TRUCK, SURVEILLANCE RECONNAISSANCE VEHICLE (SRV-SF), LIGHTWEIGHT, FFR, W/WINCH, MC2, LAND ROVER 110, 4X4, ISUZU DIESEL ENGINE

INSTALLATION OF 24 VOLT CIRCUIT BREAKER COVERS

MODIFICATION INSTRUCTION

Figure 1 Screws To Be Removed

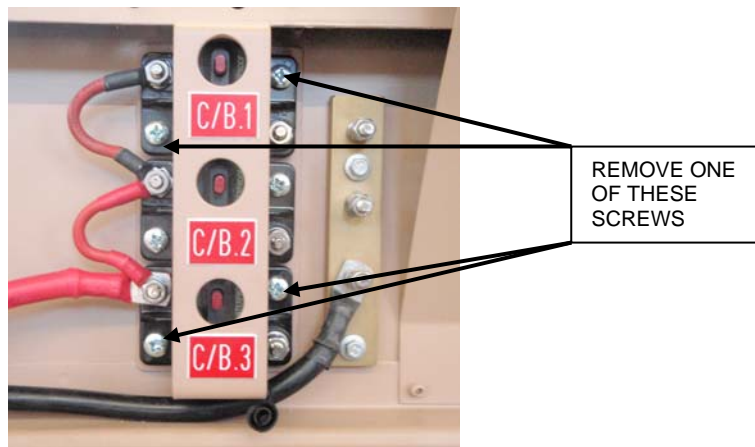
10. Items to be Removed. Four M6 x 25 mm screws and Nyloc nuts as shown in Figure 1 are to be removed. All stores removed are to be processed in accordance with the ESCM, Volume 4, Section 3 – Supply Management Processes, Stores Accounting General.

- a. Disconnect the 24 V batteries.
- b. Remove an M6 x 25 mm screw from one side of circuit breaker one and three, designated C/B.1 and C/B.3 (Figure 1).

- c. Insert two M6 x 30 mm hex head screws (Table 1, Serial 1) from the tub side.
- d. Secure the screws with a 6 mm spring washer and 6 mm plain nut (Table 1, Serials 2 and 3).
- e. Repeat sub-para b and c for the other two screws.
- f. Install the perspex cover over the 6 mm screw threads that are exposed on the front side of the circuit breakers.
- g. Secure the perspex cover with the 6 mm plain washer and new Nyloc nuts (Figure 2).
- h. Reconnect the 24 V batteries.
